SUBJECT: 24-MONTH FUEL CYCLE, LIMERICK GENERATING STATION, UNITS 1 AND 2
(TSCR NO. 92-01-0) (TAC NOS. M83334 AND M83335)

PHILADELPHIA ELECTRIC COMPANY
DOCKET NO. 50-352
LIMERICK GENERATING STATION, UNIT 1
AMENDMENT TO FACILITY OPERATING LICENSE

PHILADELPHIA ELECTRIC COMPANY
DOCKET NO. 50-353
LIMERICK GENERATING STATION, UNIT 2
AMENDMENT TO FACILITY OPERATING LICENSE

SAFETY EVALUATION BY THE OFFICE OF NUCLEAR REACTOR REGULATION
RELATED TO AMENDMENT NOS. 56 AND 21 TO FACILITY OPERATING
LICENSE NOS. NPF-39 AND NPF-85
PHILADELPHIA ELECTRIC COMPANY
LIMERICK GENERATING STATION, UNITS 1 AND 2
DOCKET NOS. 50-352 AND 50-353

Attachment: Two-stage SRV Figure

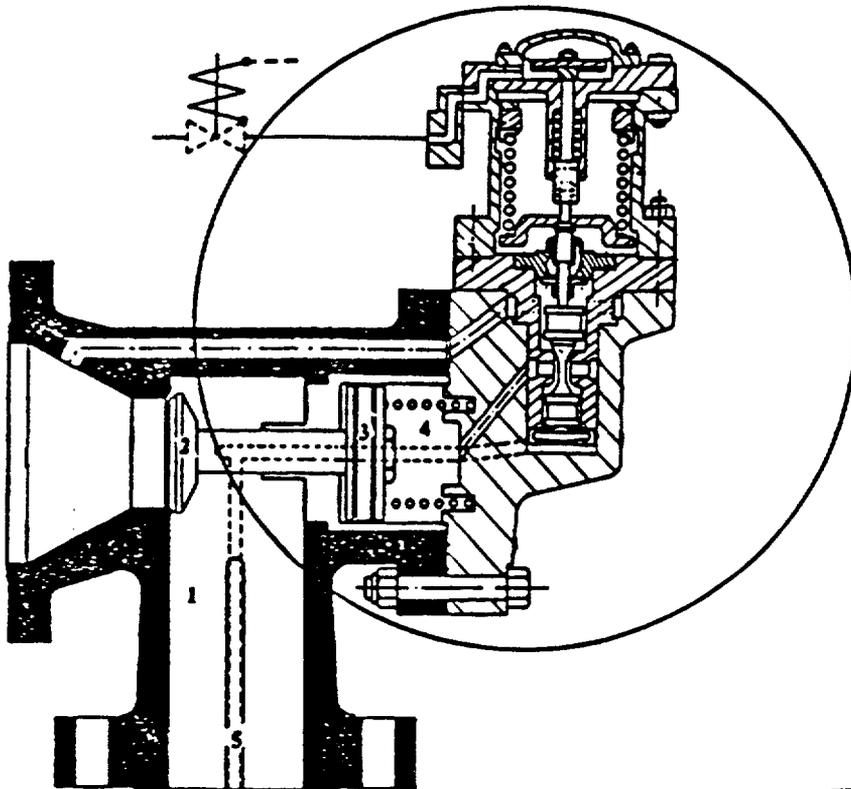
The two-stage SRV consists of a pilot stage assembly and a main stage assembly. Principal parts of the pilot stage assembly are the body, main disc, main spring and internal porting for the pilot stage as shown in the attached figure. Principal parts of the pilot stage are the bonnet, the stabilizer disc, the pilot disc, the set pressure spring, and the pneumatic operator. The shape of the pilot disc-seat interface in the SRV is conical. It is much smaller than that of a safety valve. The shape and size of the disc-seat interface affects the forces which tend to oppose the disc lifting on system pressure. The smaller size and conical shape concentrate the forces opposing lift of the pilot disc, while the larger, flat disc-seat interface of the safety valve is less sensitive to these forces.

With respect to operation of the SRVs, when the pressure under the stabilizer disc reaches the setpoint of the valve, it will push the pilot disc upward, releasing the pressure behind the main piston into the discharge of the SRV. The differential pressure across the piston will lift the main disc, relieving reactor coolant system (RCS) pressure. The ADS and manual modes are initiated by the pneumatic actuator raising the pilot stem and can be done at any pressure. The SRVs are installed to prevent overpressurization of the RCS by lifting at the required setpoint to relieve pressure and to maintain RCS pressure boundary integrity by reseating tightly without leakage.
